Re: Vapor Intrusion and Groundwater Evaluation
Conbraco Industries, Inc.
Matthews, North Carolina
EPA ID No. NCD 107 868 812
Docket No. 04-2003-4013

SUBJECT: Draft Vapor Intrusion Assessment and
Review of Groundwater Investigation Recommendations
Conbraco Site
Matthews, North Carolina

Conbraco Facility area topographic map

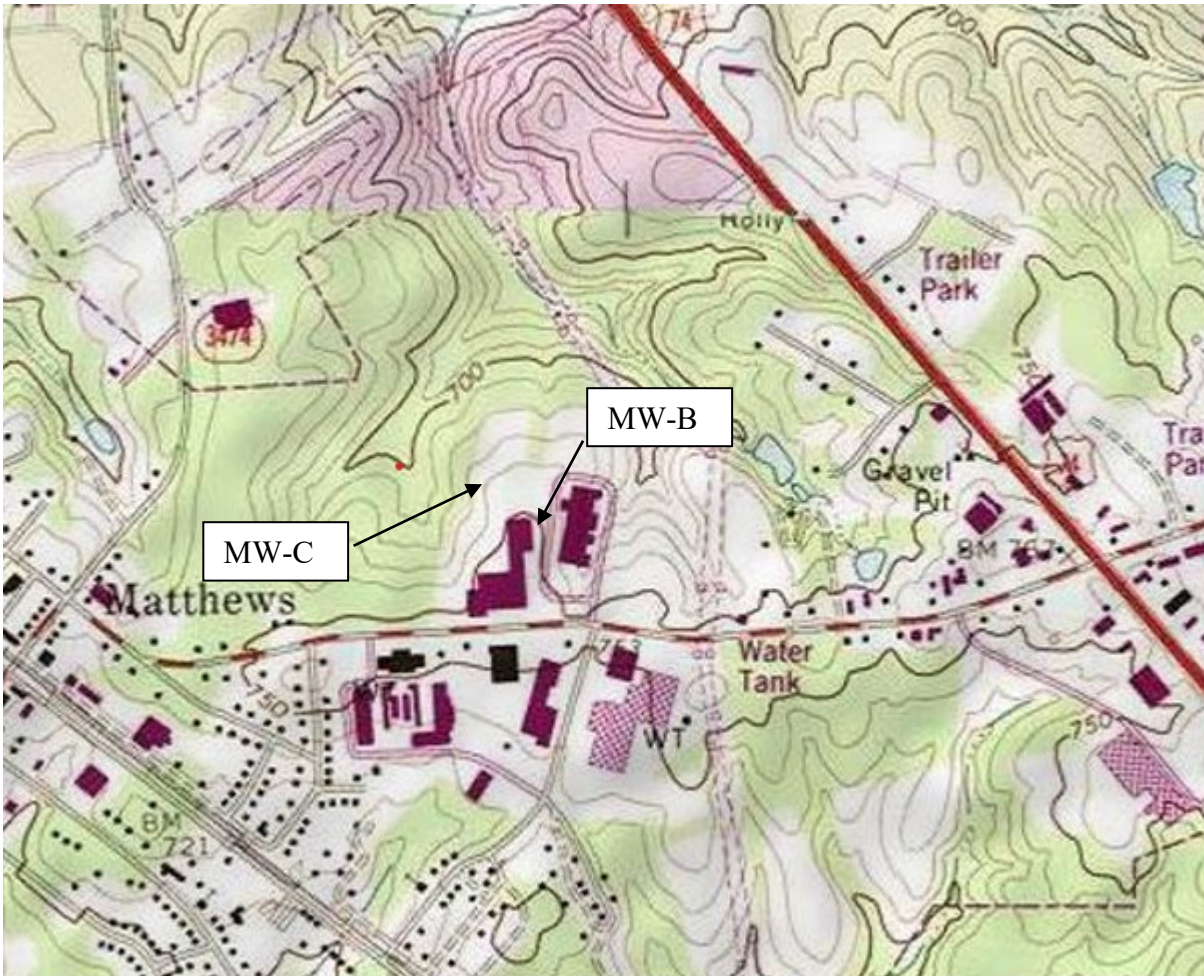
This is not very crisp nor current image, but it does show a number of general features of the area. The east-west road is Matthews Mint Hill Road and it is on the topographic ridge and drainage divide. That darker line is the 750' contour and the terrain is lower to the south and north. Also, the water tower is on the ridge and those are always placed on the high ground. At this larger scale, some general statements about the shallow GW flow directions can be made. The Conbraco facility is the building directly east of the town name, Matthews. The 700' contour to the north of the Conbraco facility provides indications as to the direction of shallow GW flow, relying upon an understanding of North Carolina Piedmont hydrogeology. On the northwest side of the Conbraco facility, the shallow groundwater flows to the north-northwest, towards the '700' label. This would be applicable

to groundwater monitored by MW-C. On the east side of the building, the shallow groundwater is moving to the northeast, under the adjacent building and moving to that little contour line feature that extends to the south. The groundwater flow direction maps of the Conbraco facility only cover the property. The limited data on the east side of the building indicates a groundwater flow direction to the northeast. This broader view allows for the indication of a more northeasterly groundwater flow direction than is indicated in the December 1988 groundwater flow direction map from Law Engineering. This more northeasterly interpretation would more likely indicate that the groundwater monitored by MW-B is coming from underneath the Conbraco facility.

FIGURE 2

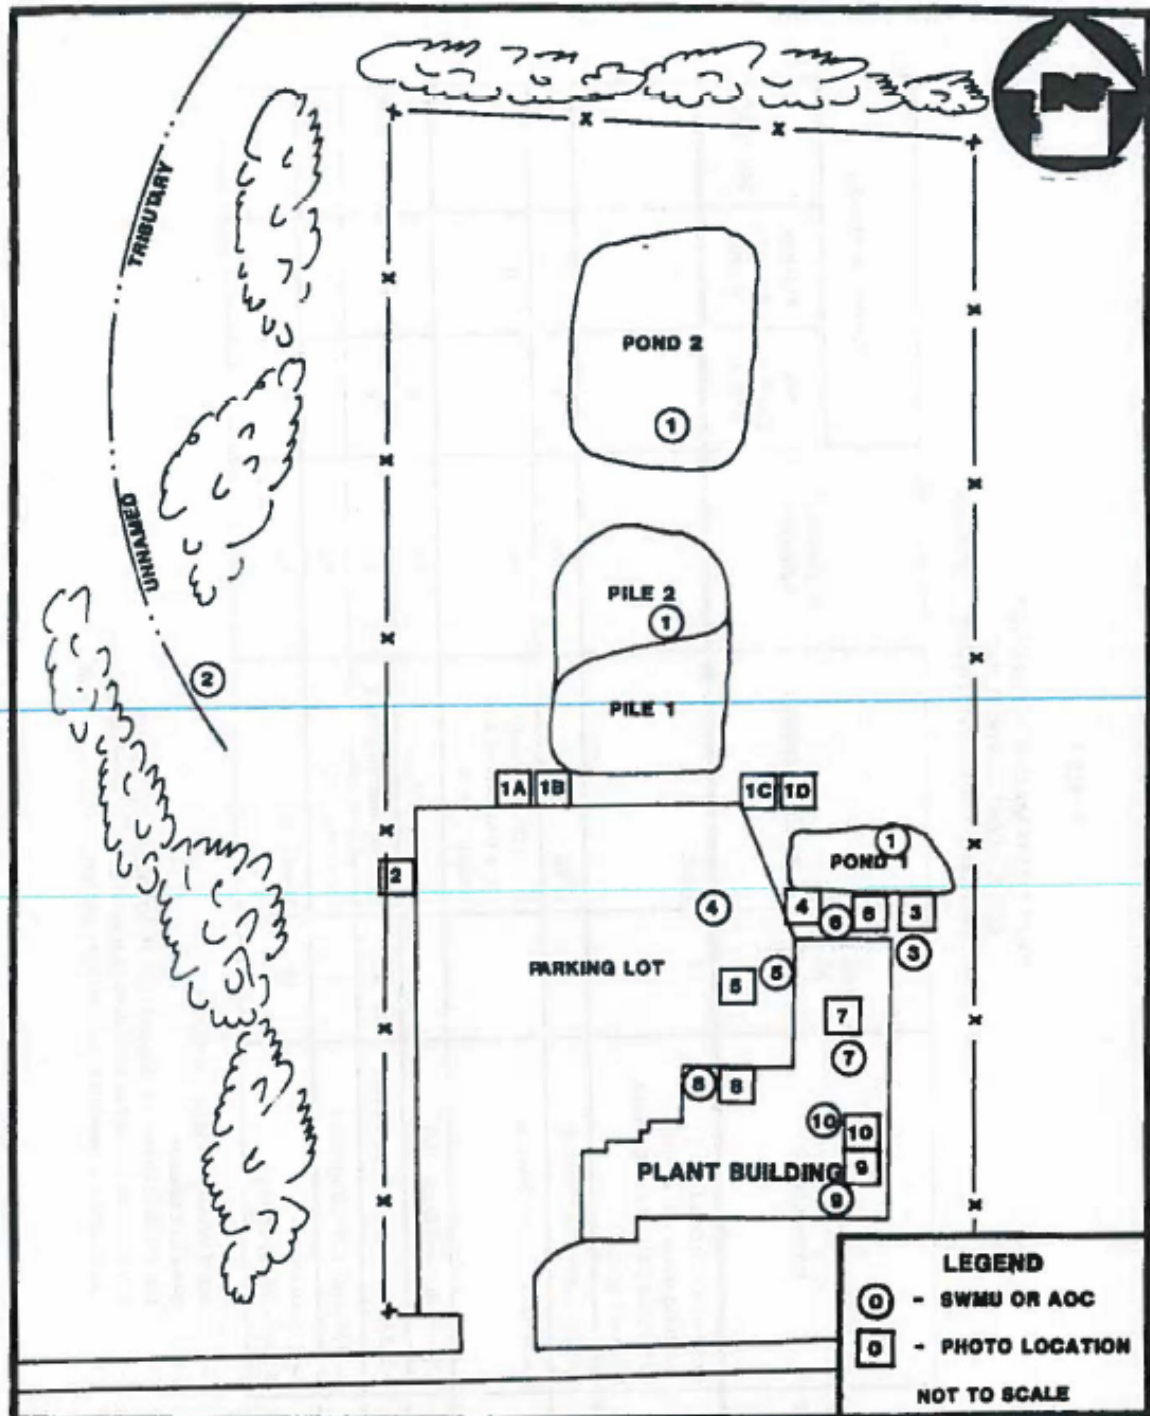
These three SWMU descriptions provide the basis for the Vapor Intrusion (VI) conceptual site model and potential releases of solvents in the facility. Completed, machined parts were placed in a batch degreaser in the early days and later in a degreaser that had a conveyor mechanism (SWMU 9). This mechanism was within an 866-gallon containment structure. SWMU 10, the satellite drum area was located near the degreaser in the southeastern corner of the facility. A 55-gallon drum was used to contain sludges and waste 1, 1, 1-trichloroethane from the degreaser unit. (This is unusual in that all the analytical data provided contained analytical results for trichloroethylene but not 1,1,1-trichloroethane.) SWMU 8 comprises a series of four floor drains, the associated plumbing that brought the waste (water) to a sump (installed in 1989) prior to discharge to the city of Charlotte sewer system. The location and flow direction of the municipal sewer lines is not confirmed at this time.

tributary' seen on the figure below and the earlier topo map. This implies a northwester to north-northwest shallow groundwater flow direction on the west side of the building and a shallow groundwater flow direction to the northeast on the east site of the building. We can not be more specific without monitoring wells within or adjacent to the facility. MW-C is located nearly 570 feet to the north northwest and it monitors groundwater that exits from under the facility in the vicinity of the sump in the July 1990 building configuration. That would put it approximately 750' from the location of the degreaser. The older NUS figure and the topo map do not show an addition that was added in approximately 1990, after the NUS site visit. The intervening distance is covered with asphalt and concrete with limited possibility for rainwater infiltration and groundwater recharge/dilution. MW-B is located NE of the NE corner of the facility also with asphalt cover allowing for limited recharge or groundwater recharge/dilution. It is on the groundwater flow path from spills or releases that may have occurred on the east side of the building, such as from the degreaser or the satalite drum storage area.

There are some data gaps in the CSM. There is a figure that was part of a SWMU closure package that shows the layout of the facility more recent than the NUS map. This figure shows multiple floor drains, the partitioning of the space at the time of the figure (office space vs factory floor), and the degreaser located in a different location than is shown on the NUS figure. That figure is not dated but shows an addition completed in 1990. The shape is approximately the same as the current image on Google. The current information available to us at the time does not confirm the continued operation of the foundry or degreaser. The current operation of either of those two units would be a complicating factor in a vapor intrusion investigation.

1. Perform an inventory of the interior spaces in the building, the type of activities and any current or historical chemical use.
2. Verify that the 1990 site map (attached) that shows the layout of the floor drains is still valid. An understanding of any in the slab utility corridors, slab penetrations and the design and function of the HVAC system will be important to the performance of a valid vapor intrusion investigation.

4. Temporary wells should be installed along the north and northeastern and northwestern perimeters of the building. MW-B and MW-C are some distance from the building. It is possible that the source of the TCE detected could be other than the degreaser. Characterizing the groundwater coming out from underneath the building will help identify the potential sources of the vapor causing chemicals.
